## MEMORANDUM

### FORMAL ACTION & RECOMMENDATION #2 MEETING OF 01-14-21

Re: **Application of the Saints Isidore and Maria Parish Corporation** (aka Saint Paul's Church) for: an **inland wetlands and watercourses permit**; and a **recommendation to the Town Plan & Zoning Commission for a Section 12 Special Permit with Design Review** concerning an **expansion of its parking lot** (119 additional spaces) **at 2755 and Assessor's Lot W-38A Main Street** – Town Center Zone – Megson, Heagle & Friend, C.E. & L.S., LLC – Davison Environmental, consultants – Alter & Pearson, LLC

Re: Proposed Parking Lot Expansion  
#2577 and Lot W-38A Main Street  
Saints Isidore and Maria Parish (Formerly St. Paul's Church)

## STORMWATER MANAGEMENT BASIN CROSS SECTION "A-A"

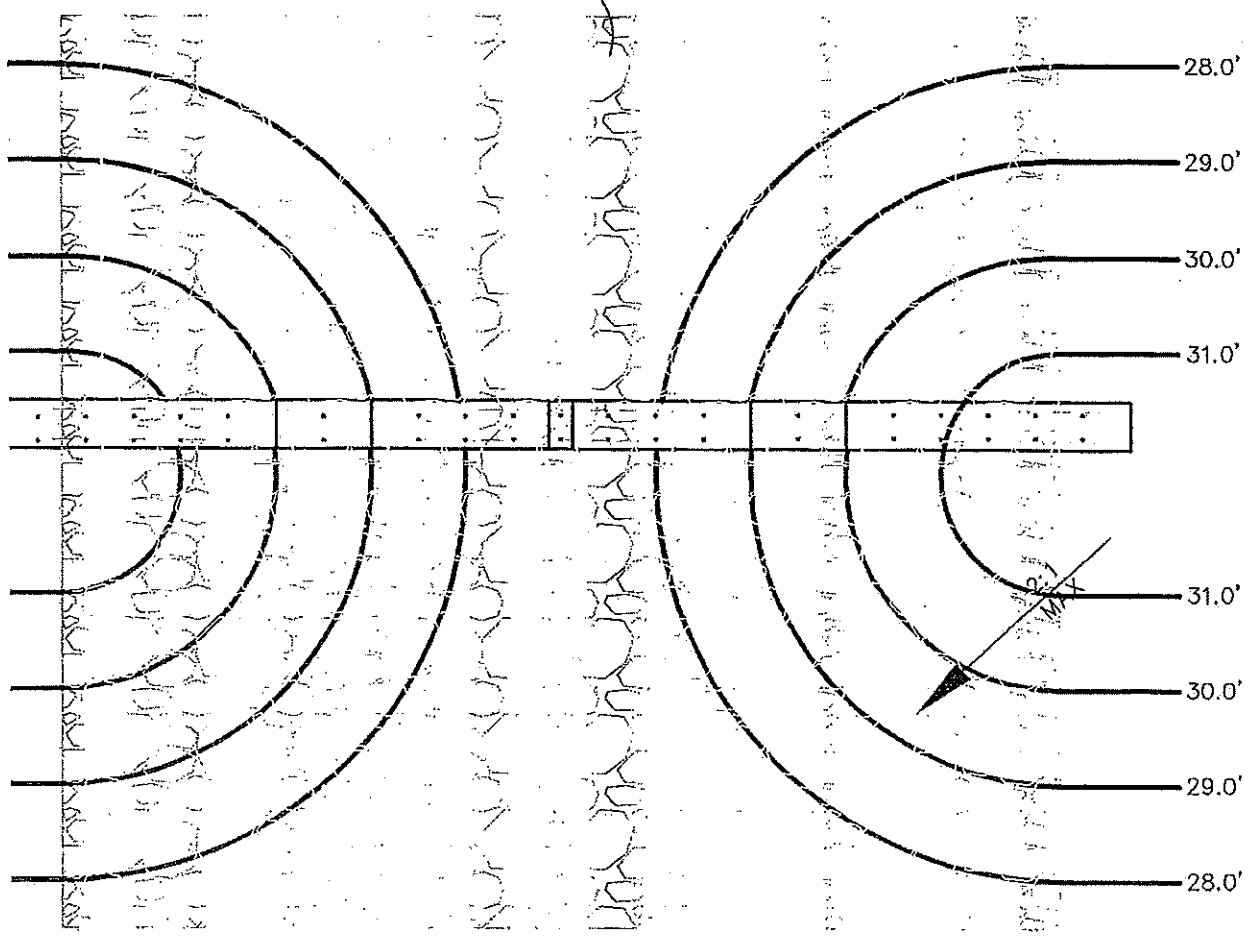
2. The low-flow weir on the stormwater basin outlet structure should be adjusted as required to ensure that the water quality volume is retained within the stormwater basin. Revise weir details and computations as required and submit for review and approval by the Town Engineer.

\*  
Based on that discussion, we agreed the design of the Stormwater Management Basin (SWMB) outlet weir should be adjusted to provide adequate storage volume for the Water Quality Volume (WQV) below the first opening which is 6 inches wide. In addition, we agreed the wet portion of the SWMB is allowed to be used for storage volume in accordance with 2004 Connecticut Stormwater Quality Manual. Consequently, I have revised the drainage calculations to reflect these changes.

By utilizing the wet portion of the SWMB the required WQV is achieved at elevation 28.5. Therefore, I propose to adjust the flow line of the 6 inch outlet weir opening from 28.0 to 28.5. As the revised drainage calculations demonstrate, adequate detention will be provided for all storm events.
